Presentation to the ACRS Subcommittee

Vogtle Early Site Permit Review Status

Section 2.5

**Geology, Seismology and
Geotechnical Engineering**

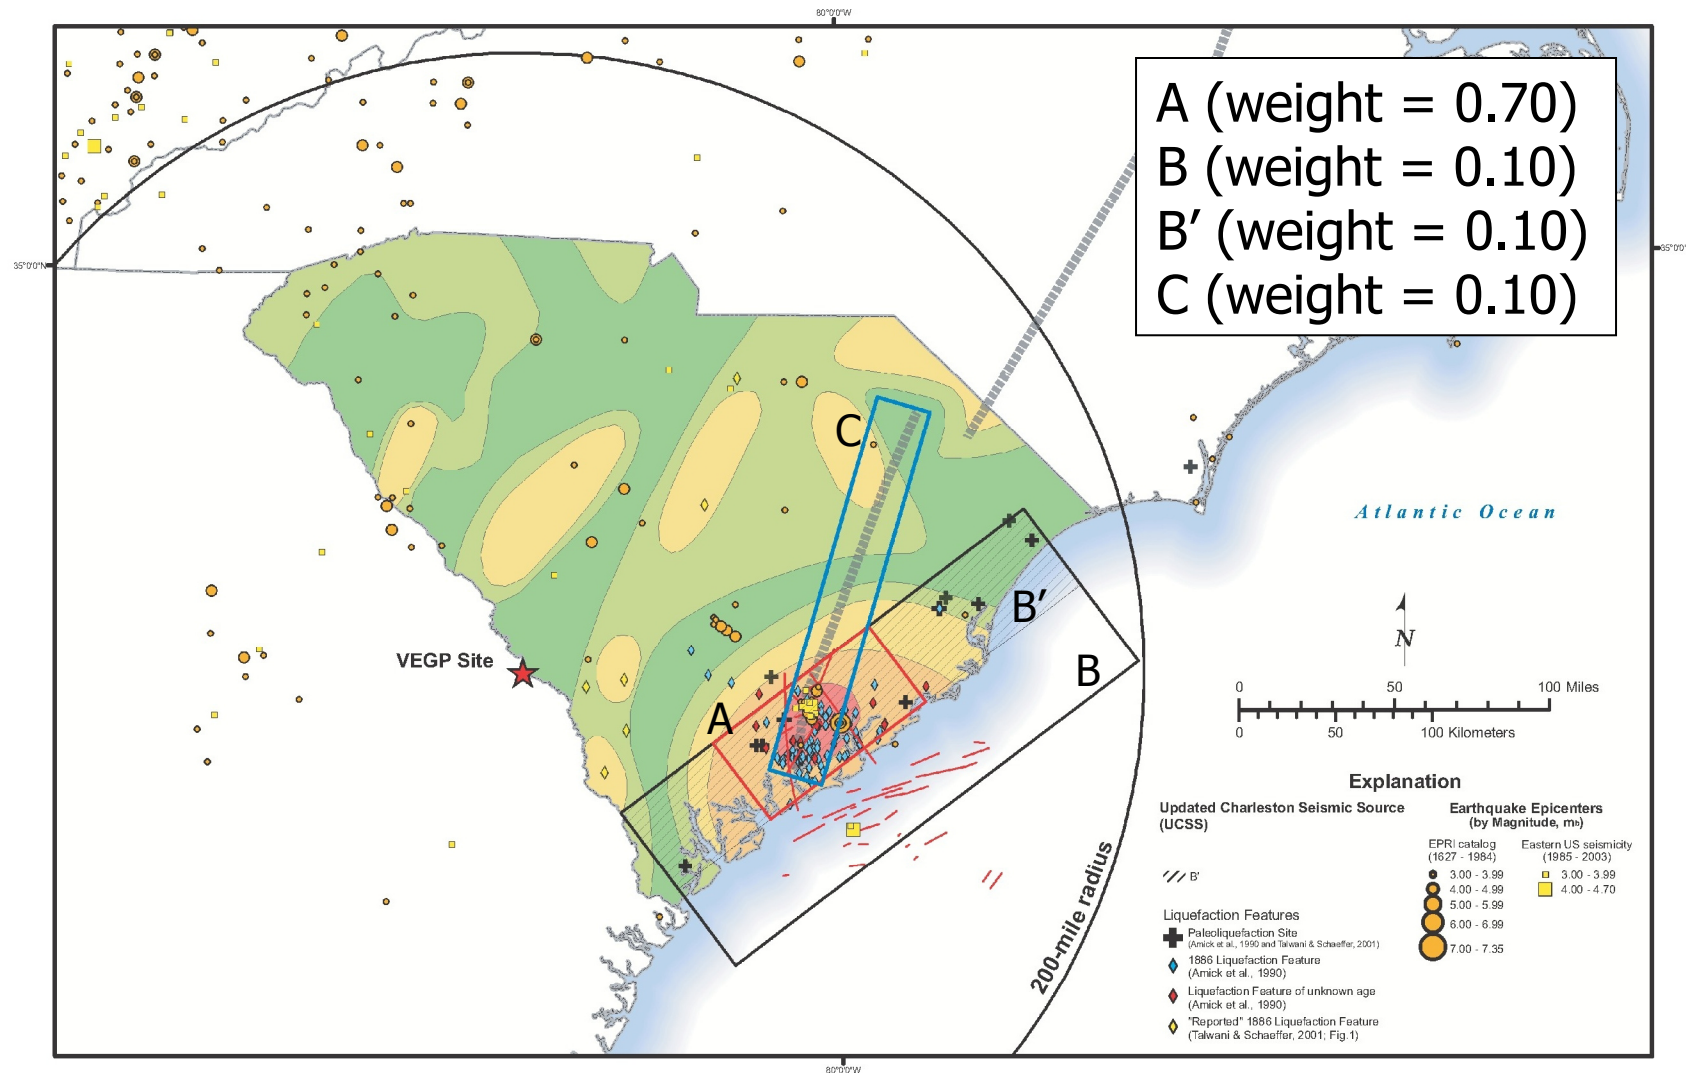
- **Charleston Paleoliquefaction (Cont'd)
(OI 2.5-5)**
 - NRC Staff concluded that the applicant did not provide sufficient paleoliquefaction evidence to rule out the occurrence of large inland earthquakes (OI 2.5-5)
 - The occurrence of a large earthquake, inland from the coast, may necessitate a different Charleston source zone model

Updated Charleston Seismic Source

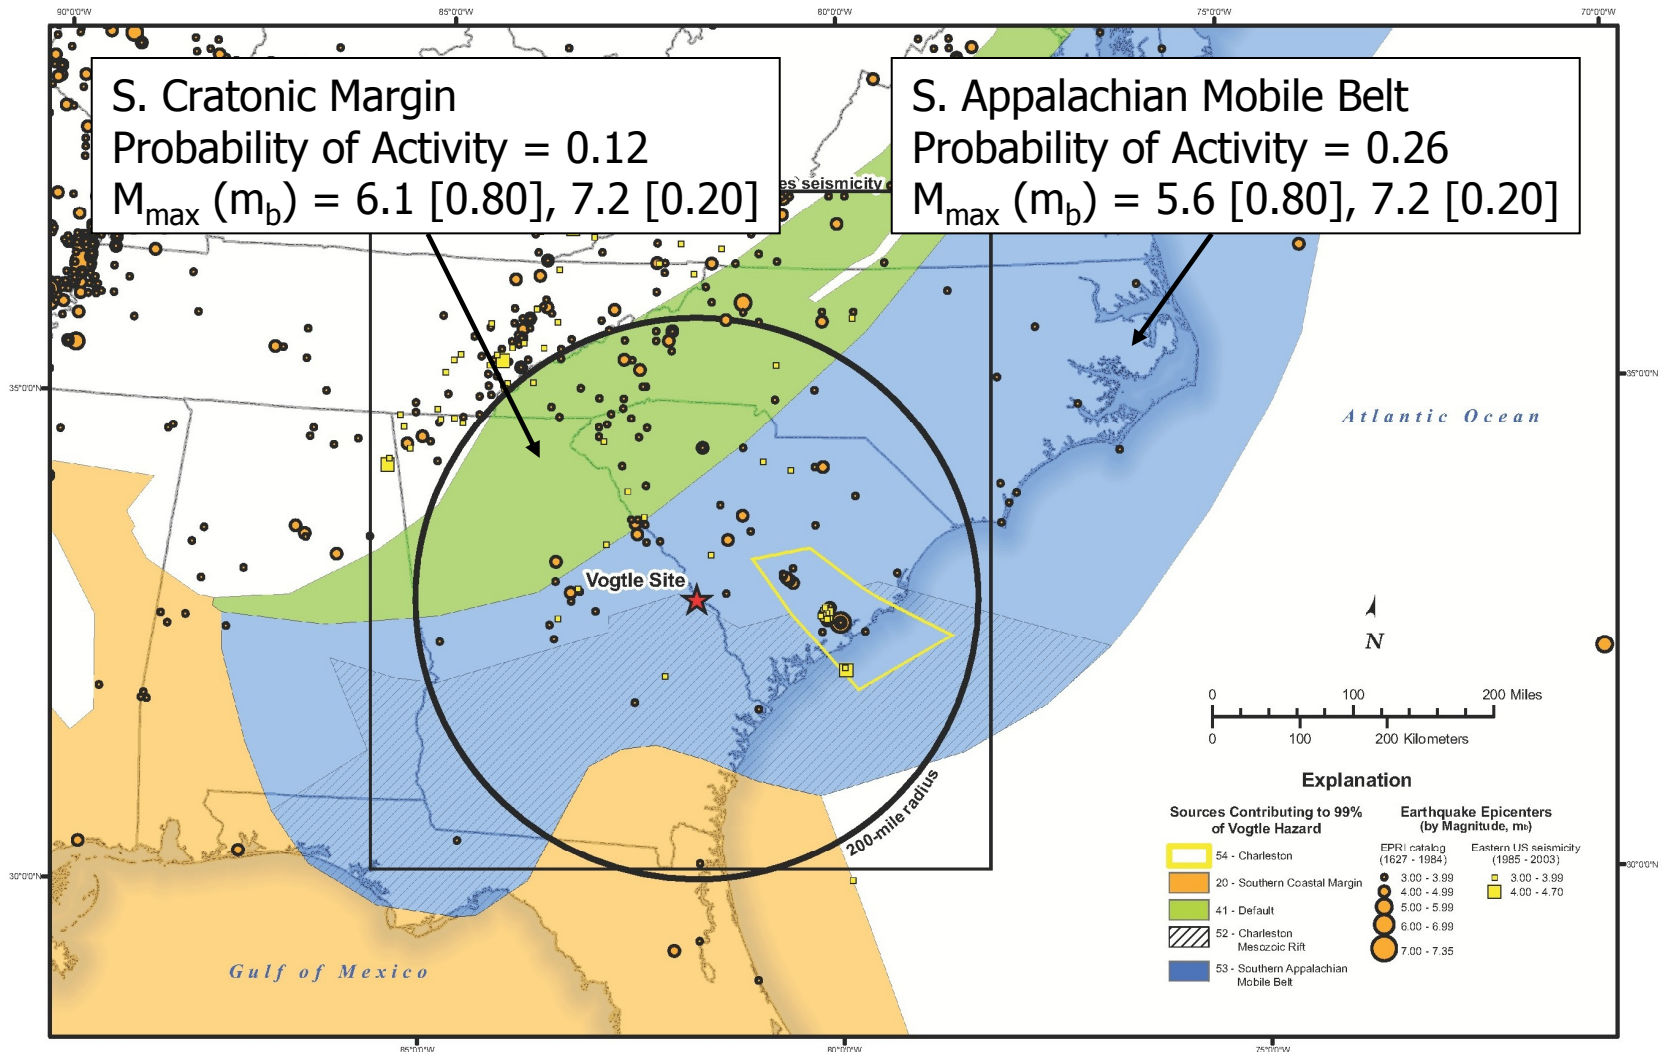
- **Charleston Seismic Source Update (OI 2.5-4)**
 - Applicant used a Senior Seismic Hazard Analysis Committee (SSHAC) Level 2 process to perform the update
 - Designated Technical Integrator (TI) responsible for conducting literature review and contacting appropriate experts
 - TI also responsible for integrating current literature and expert's views into final model
 - Staff requested additional details regarding expert elicitation process (RAI 2.5.2-4)
 - Questions asked of the expert's and their responses
 - Process used to combine the expert's responses
 - Staff has not yet completed its review of this information (OI 2.5-4)

10-Hz Total Mean Hazard Curve

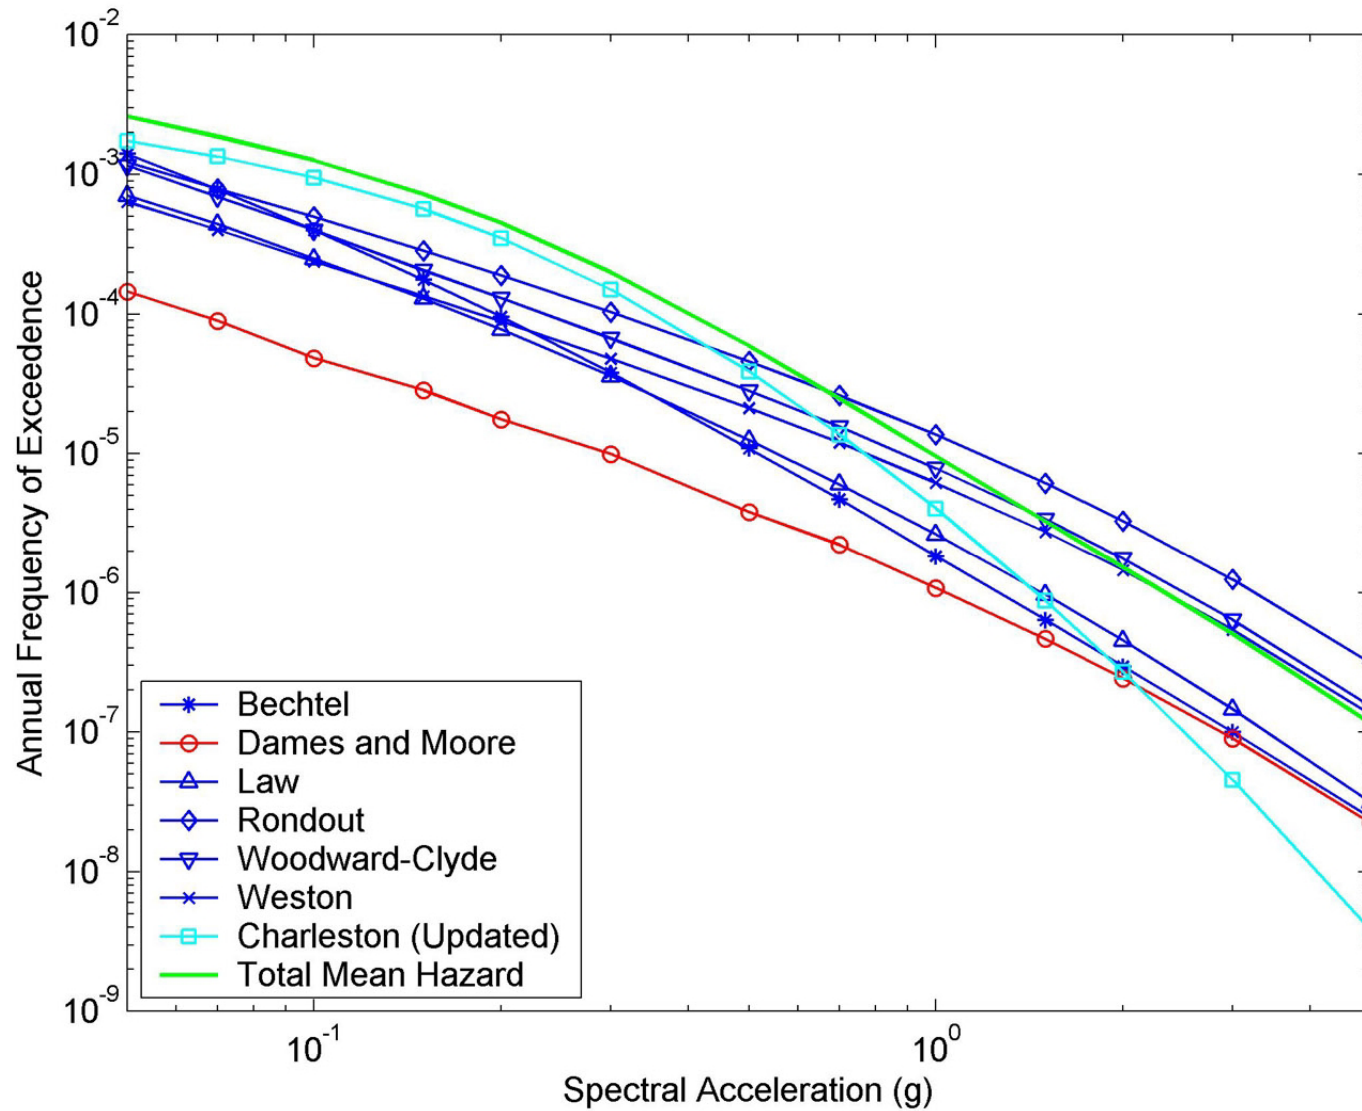
- **Regional Seismic Source Zone M_{\max} and Probability of Activity (OI 2.5-1)**
 - EPRI seismic source zones were determined by six Earth Science Teams during the 1980s
 - Dames and Moore team assigned low weights for larger M_{\max} values (and low probabilities of activity) to two of their regional source zones
 - Resulting Dames and Moore hazard curves for the ESP site do not adequately characterize the regional hazard
